RESPONSE TO COMMENTS

Re: Waterstone Site Plan No 4, DA-1758-10, 4th submittal comments

Please accept this letter in response to your December 2024 review comments on the Waterstone Site Plan No 4, DA-1758-10, 4th submittal comments.

TYPICAL RESIDENTIAL LOT PLAN

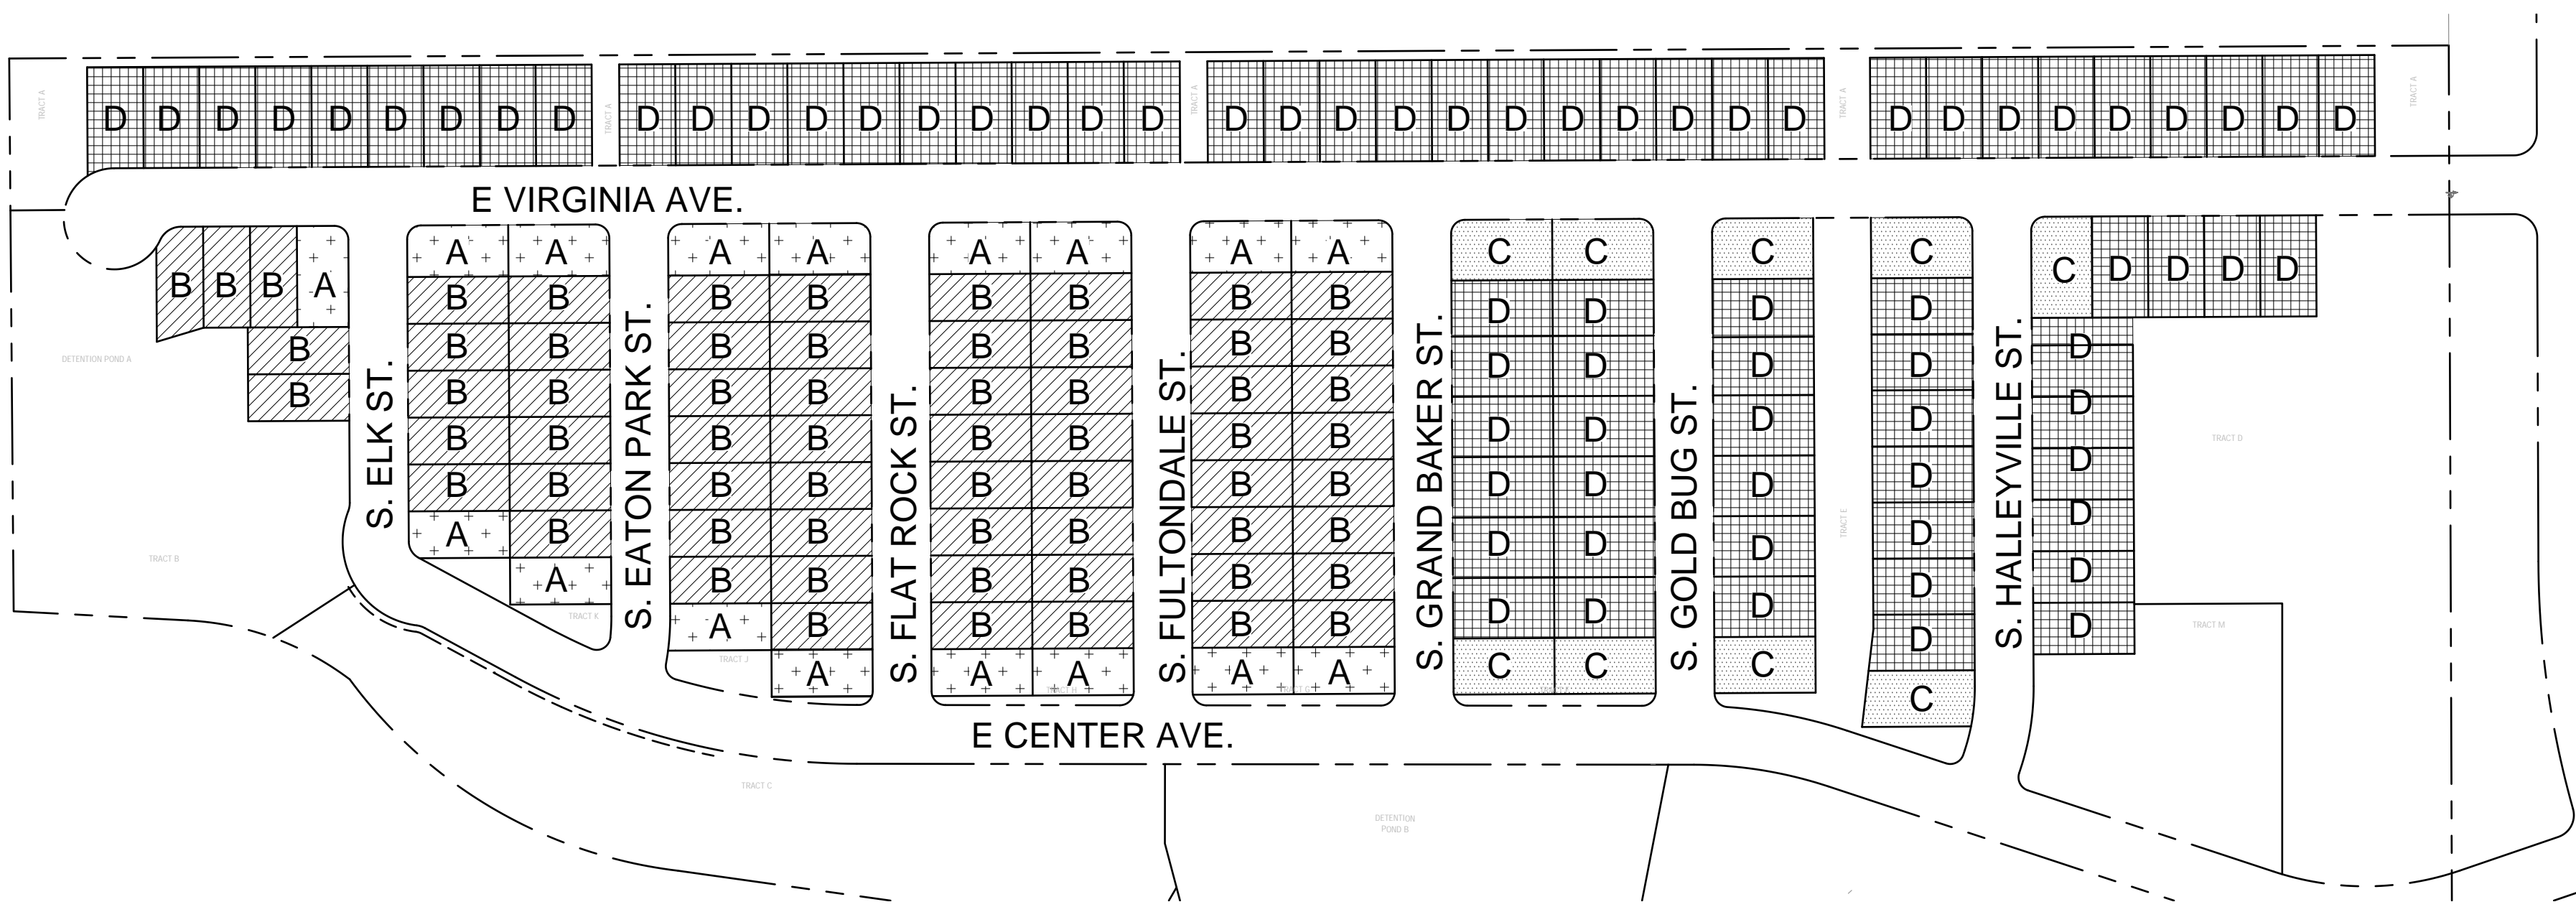
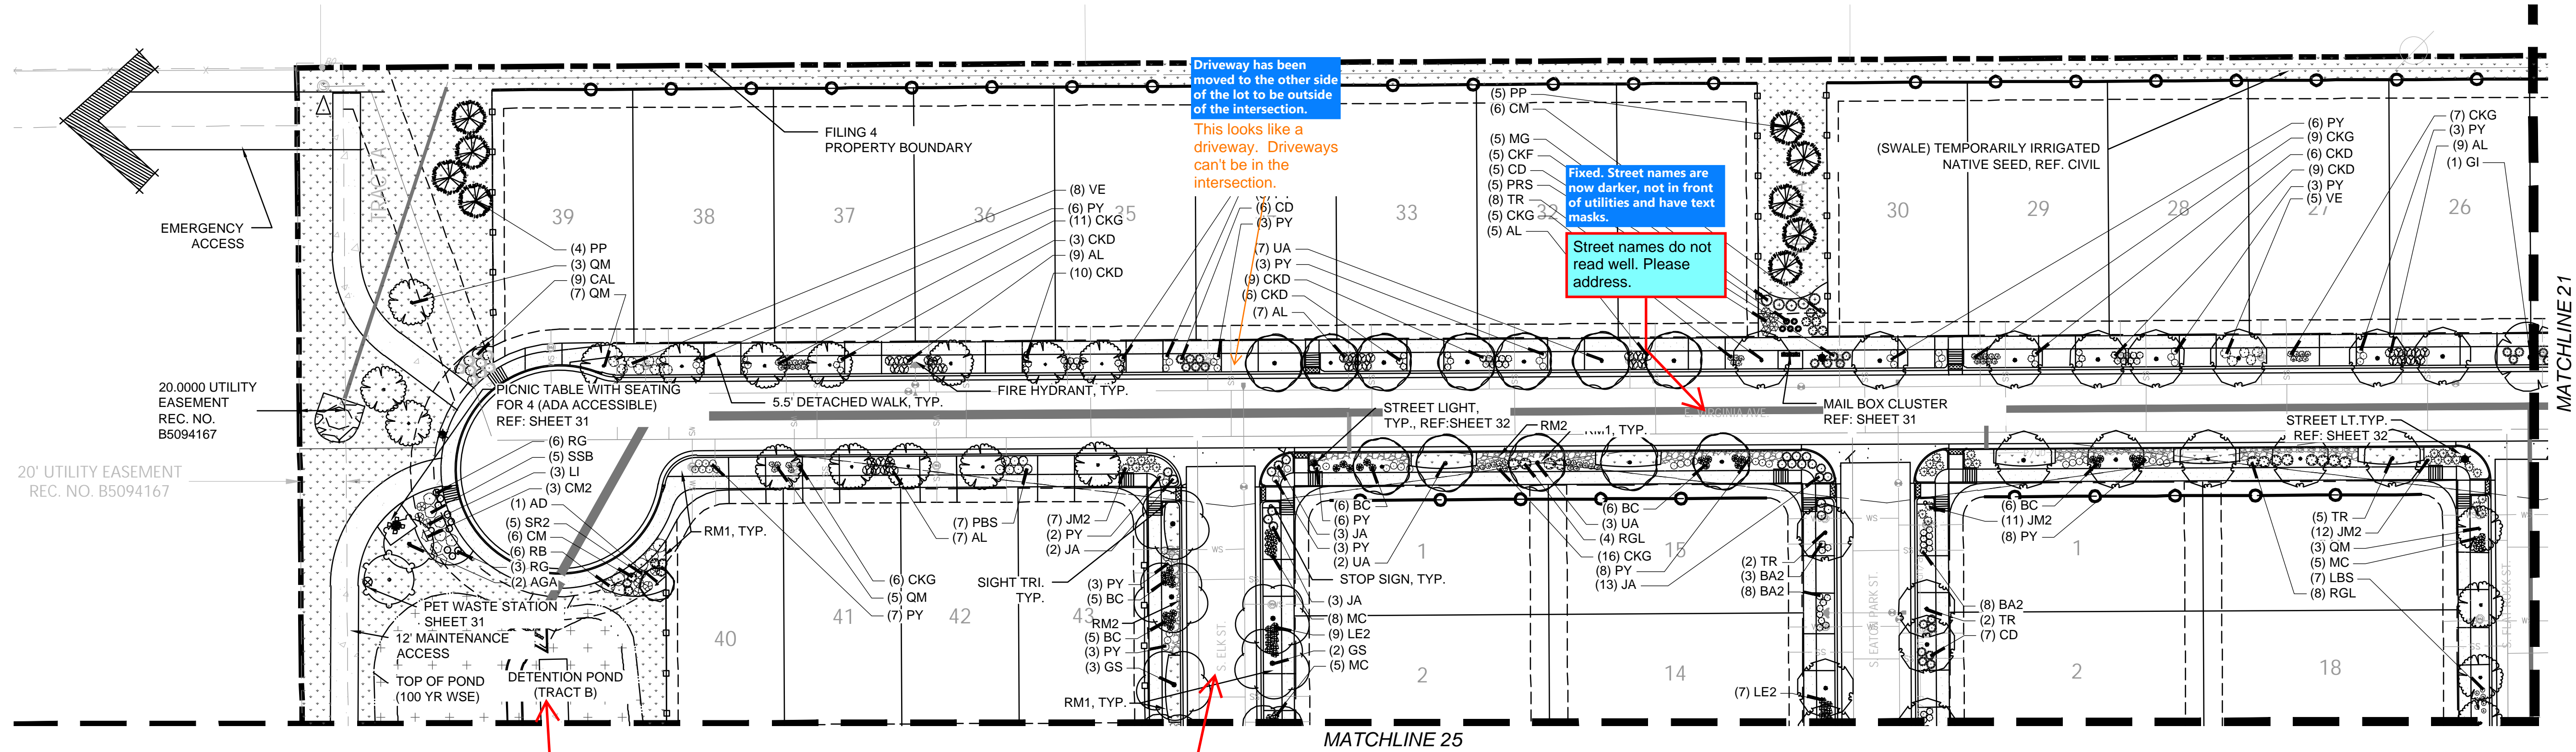
This sheet should come before the actual lot typical.

Addressed.

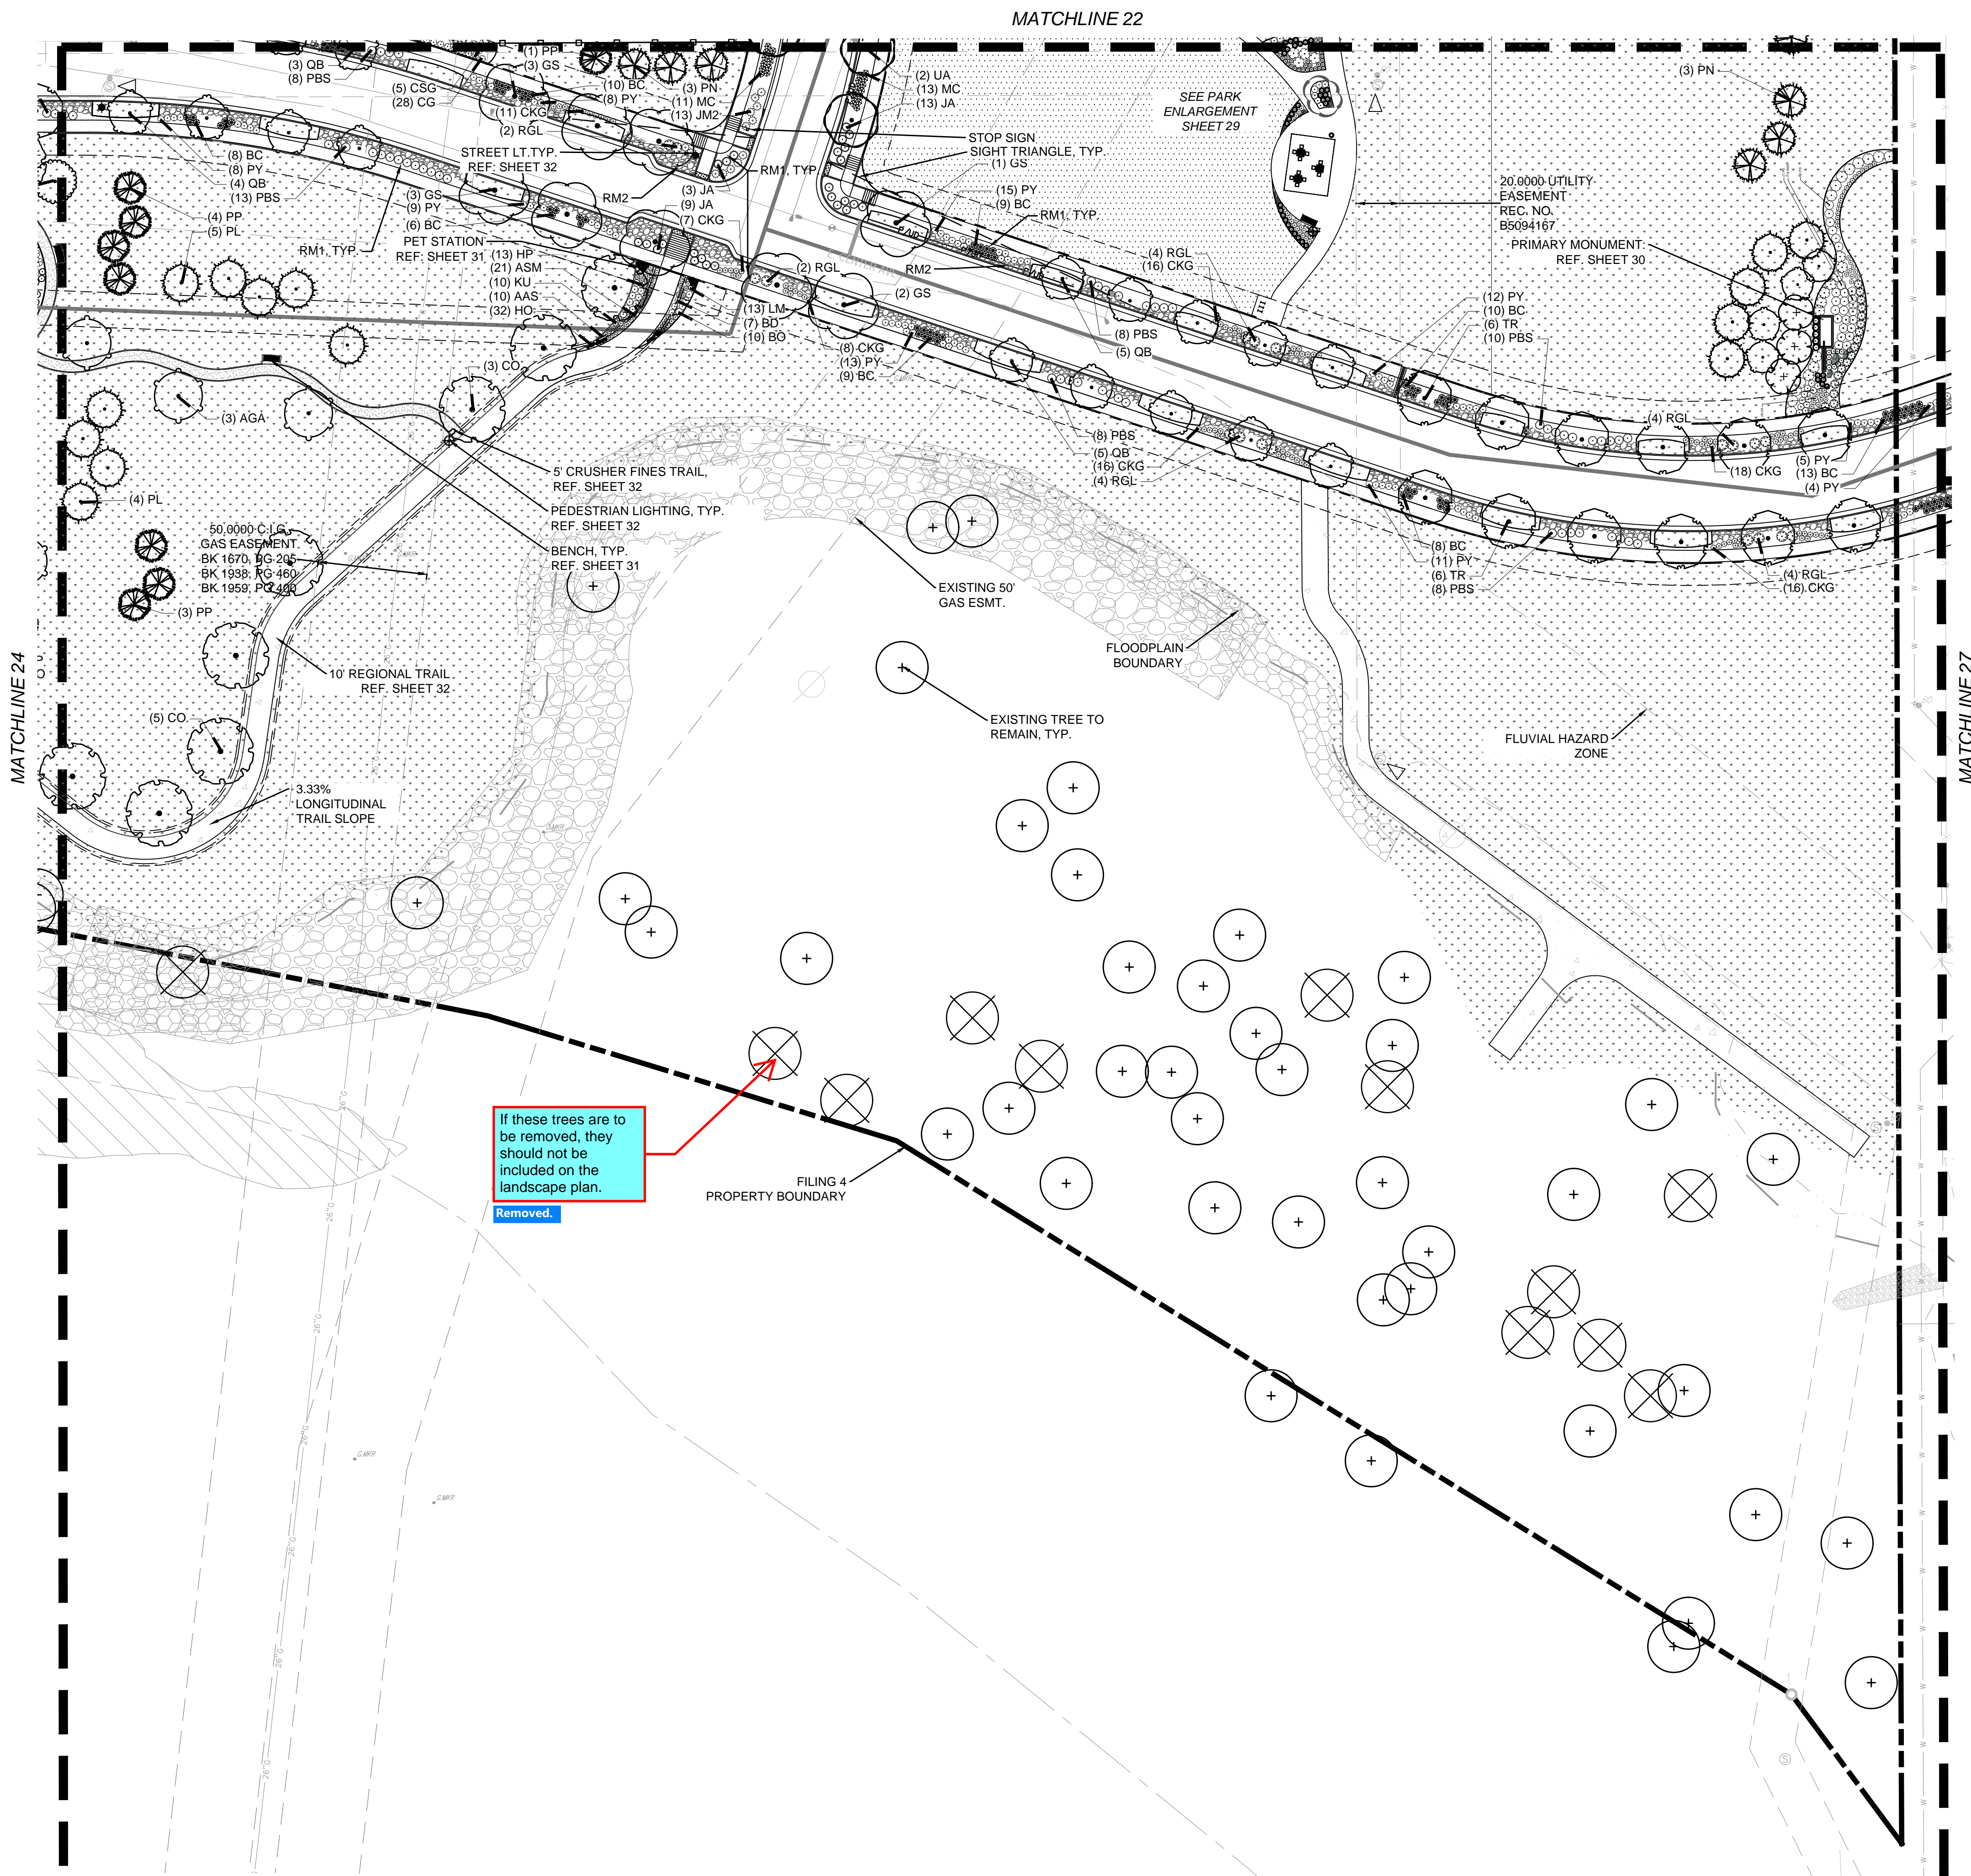
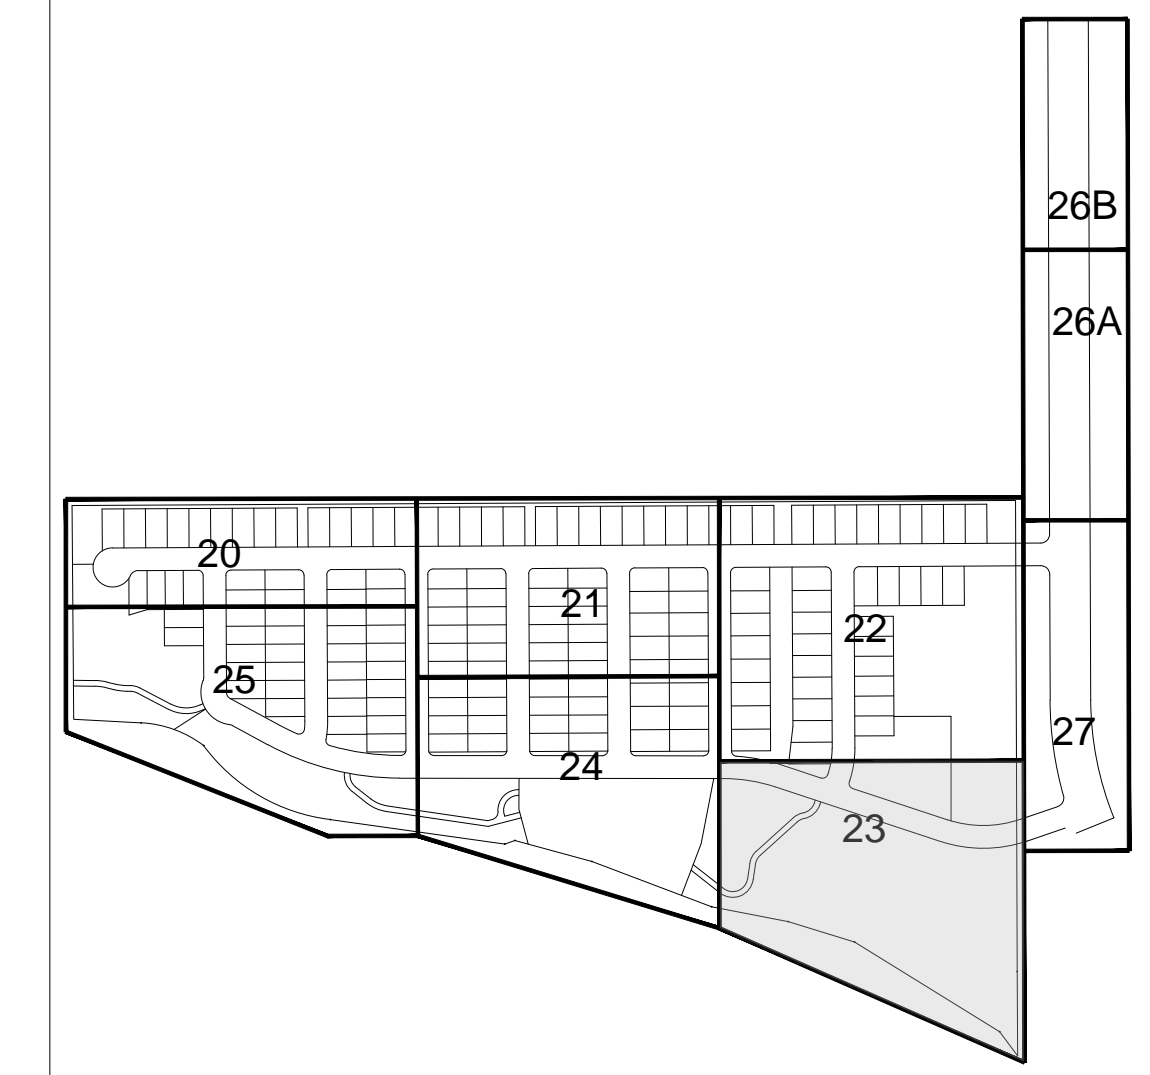
If these trees are to be removed, they should not be included on the landscape plan.

Resp: Trees being removed are no longer shown on the landscape plan.

FIGURE 10
PARKLANDS VILLAGE 2
AURORA, COLORADO
2030 TOTAL PROJECT TRAFFIC ASSIGNMENT

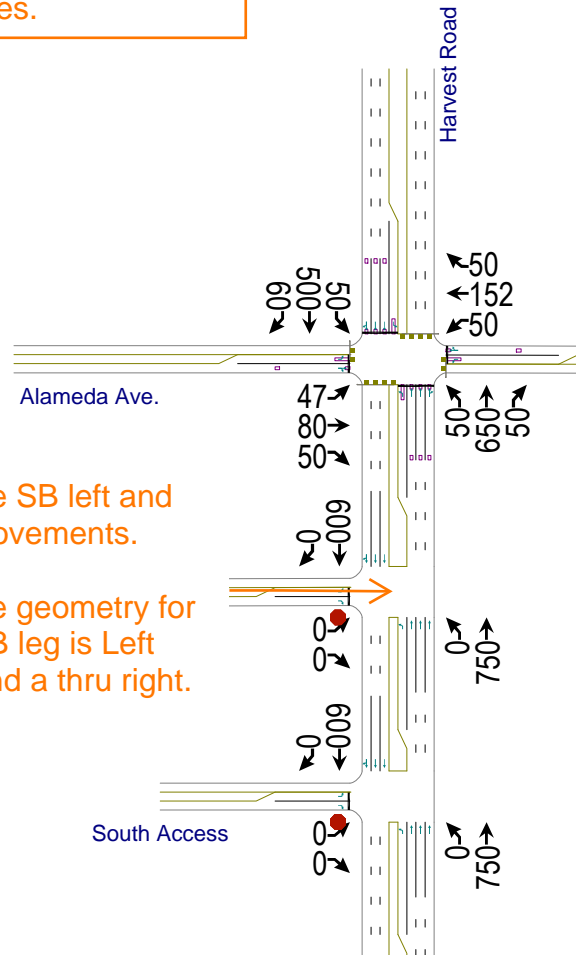
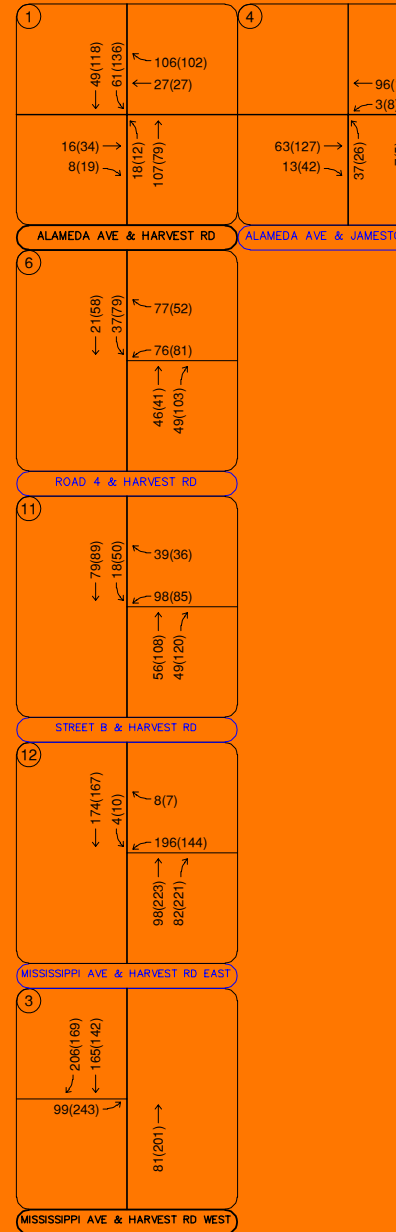
Include SB left and WB movements.

Update geometry for the WB leg is Left turn and a thru right.

Revised Accordingly
